MDI Return Loss (part 1)

NXP Semiconductors

Vienna, 15-18 July 2019

MDI Return Loss Comparison BASE-T1

Proposal visualized

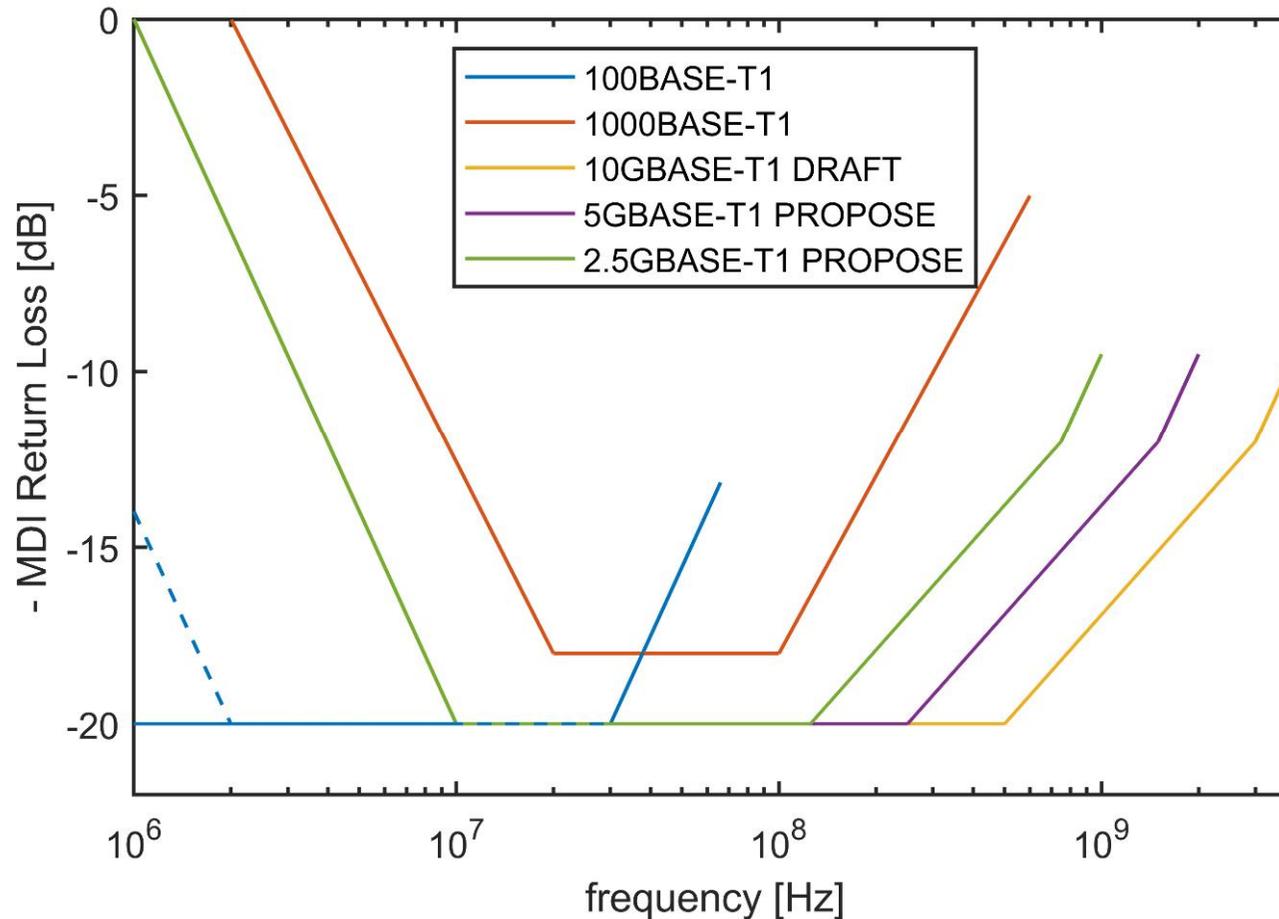
- ▶ 2.5GBASE-T1 >2x tighter than 1GBASE-T1, so sufficient

- ▶ Keeping lower corner at 10MHz
 - comment shows incorrectly an S-scaling there too

Example with single slope

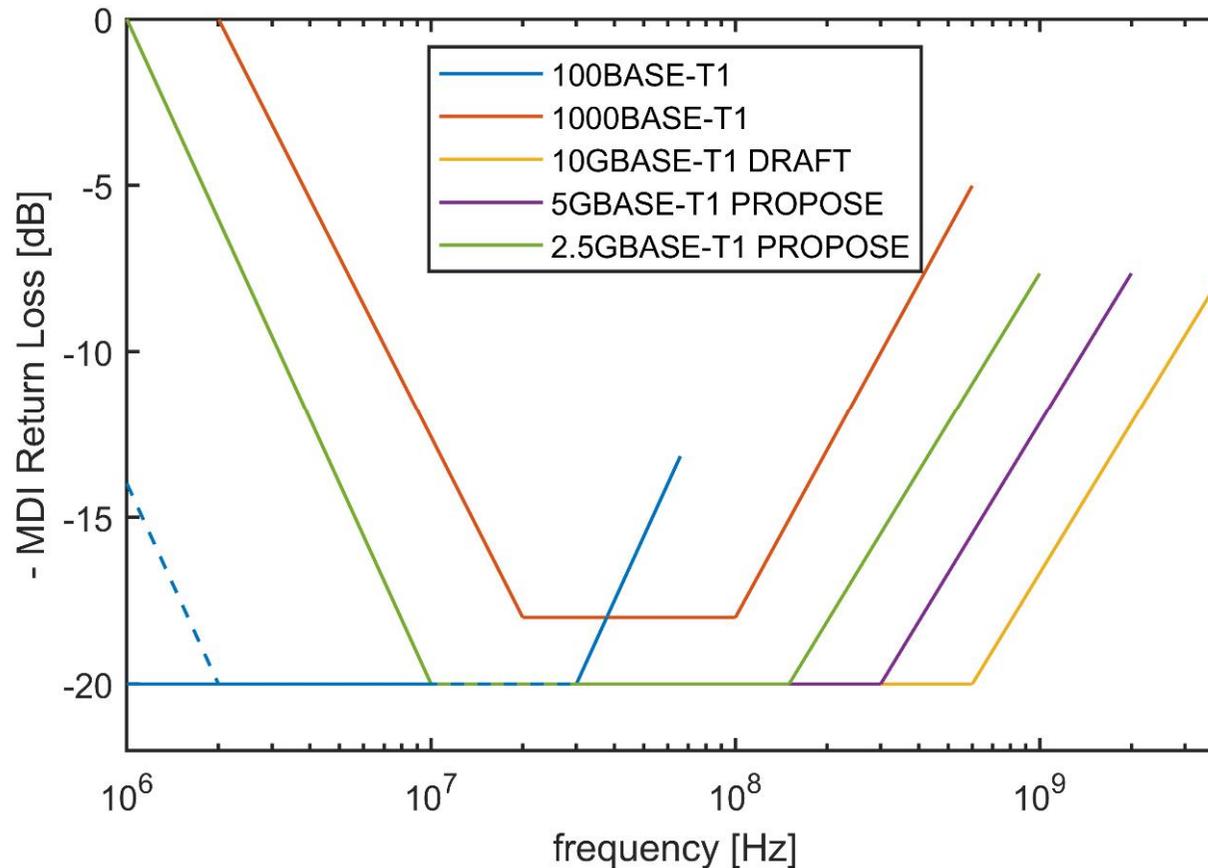
- ▶ $F > 600S \rightarrow RL_{MDI} = 20 - 15 \cdot \log_{10}(freq/600S)$
- ▶ $\sim 10\text{dB}$ at Nyquist $\rightarrow \sim 750 \text{ fF}$ for 5.625GBd

My comment version

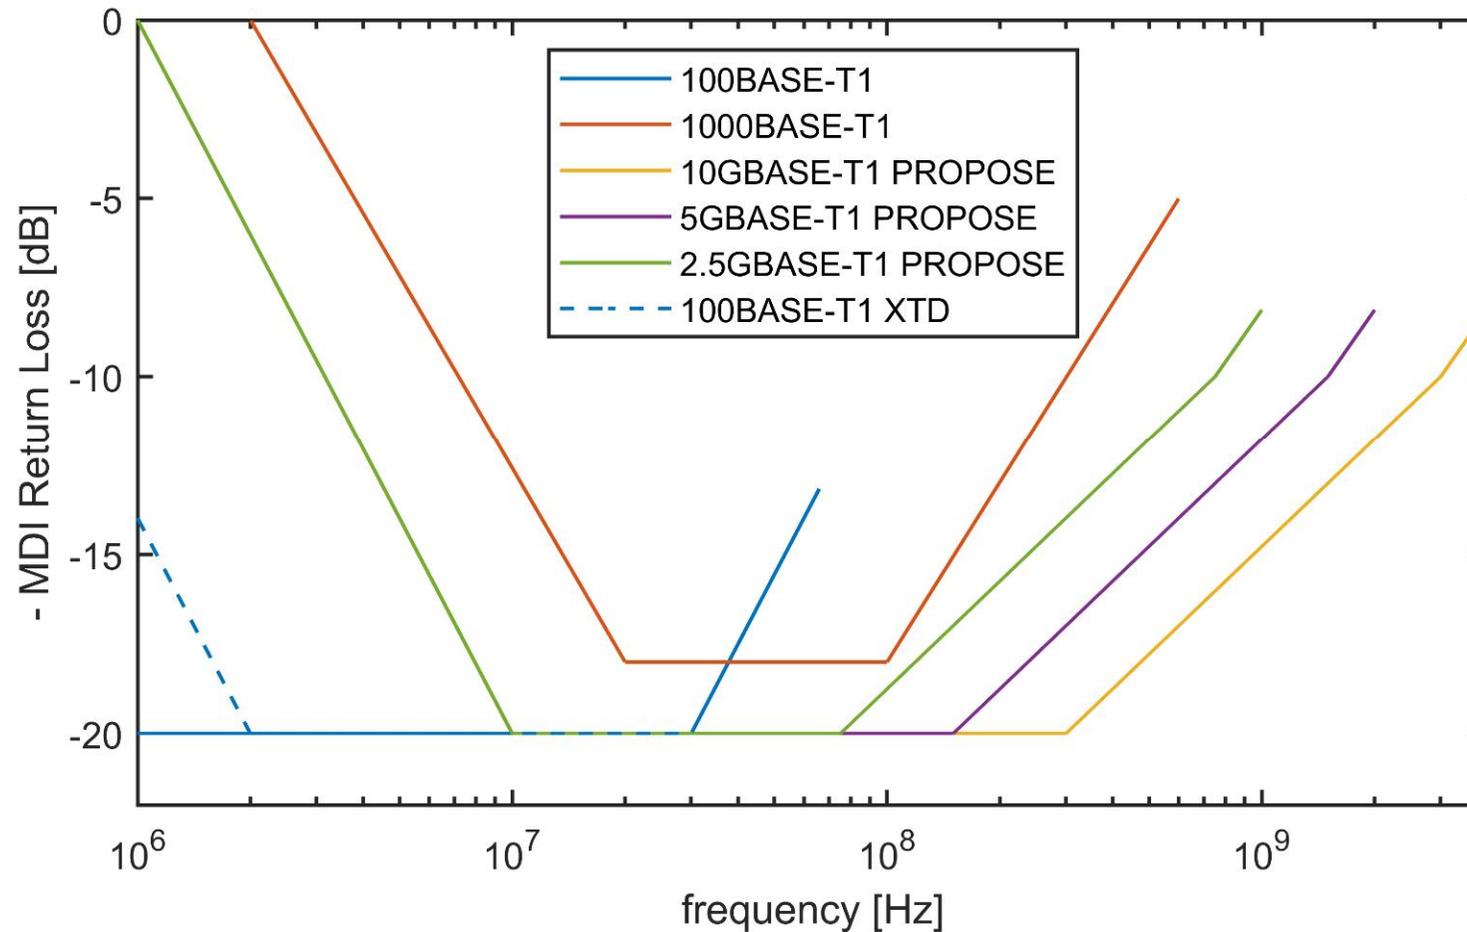
- ▶ 10dB/dec from 300S to 3000S, 15dB/dec from 3000S to F_{max}

Alternate 1

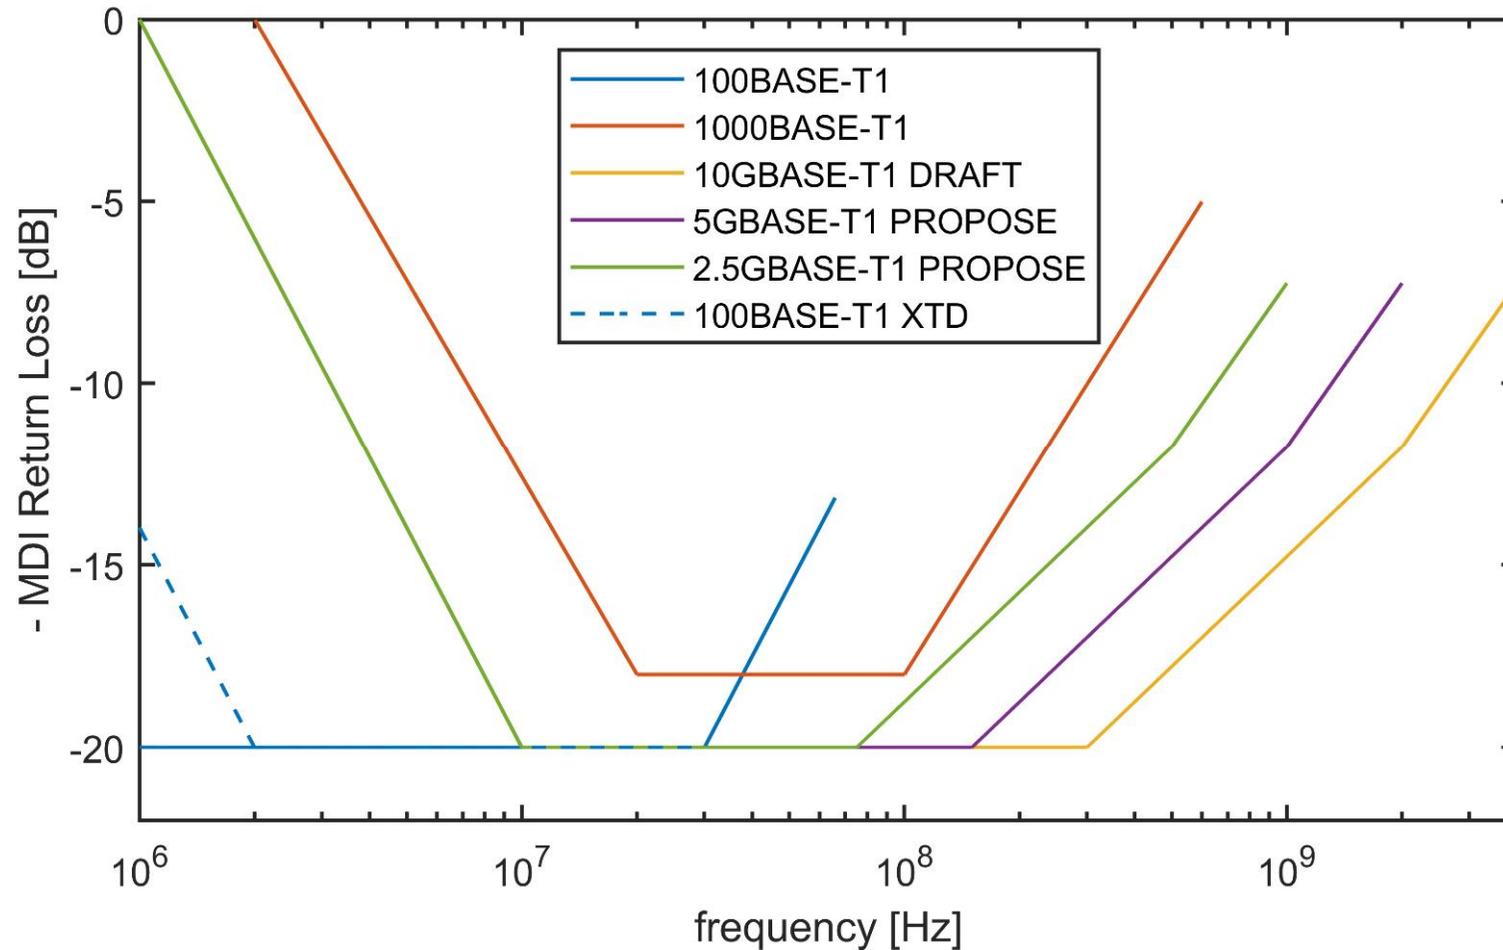
- ▶ 10dB/dec from 300S MHz, 15dB/dec from 2000S MHz

Alternate 2

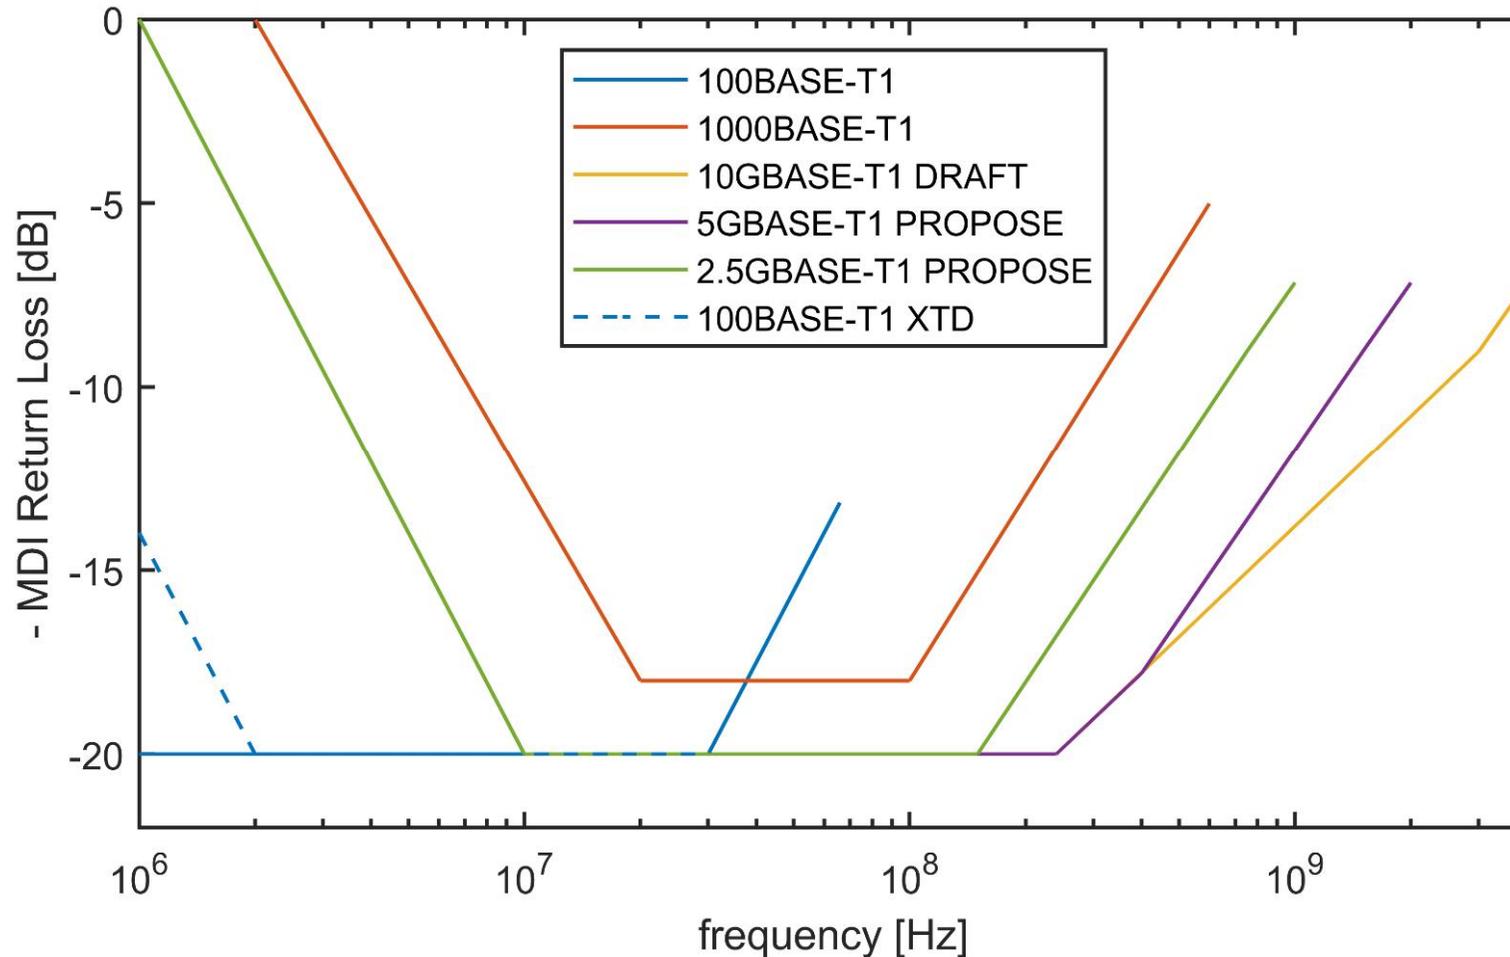
- ▶ 10dB/dec starting at 240MHz
- ▶ 15dB/dec from 600S MHz, obeying above 10dB/dec limit

Alternative 3

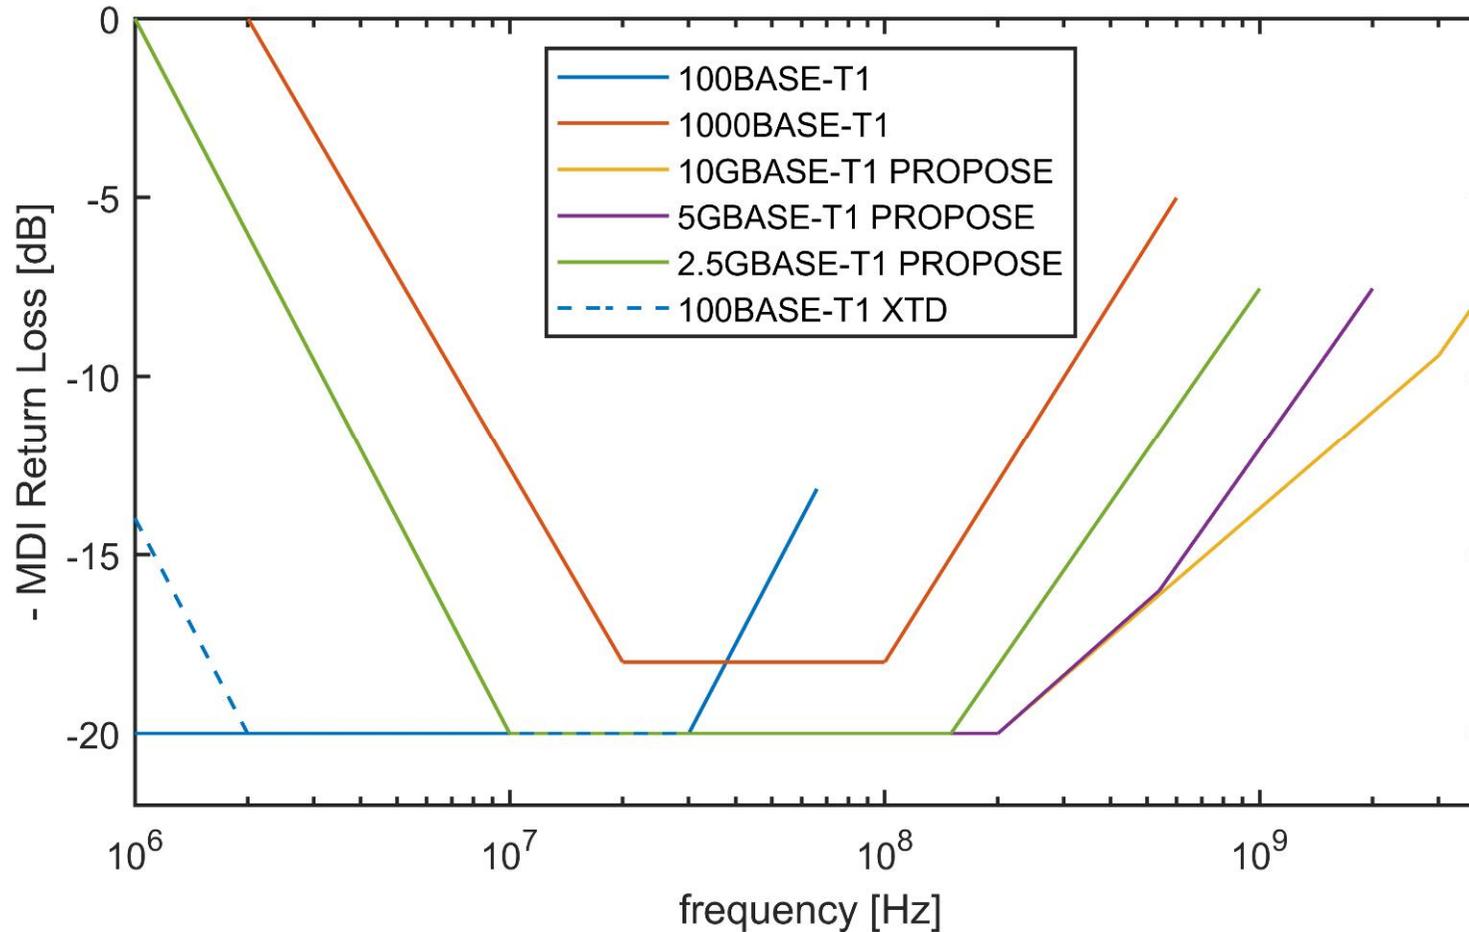
- ▶ 9dB/dec above 200MHz
- ▶ 15dB/dec from 600S MHz, obeying 9dB/dec limit
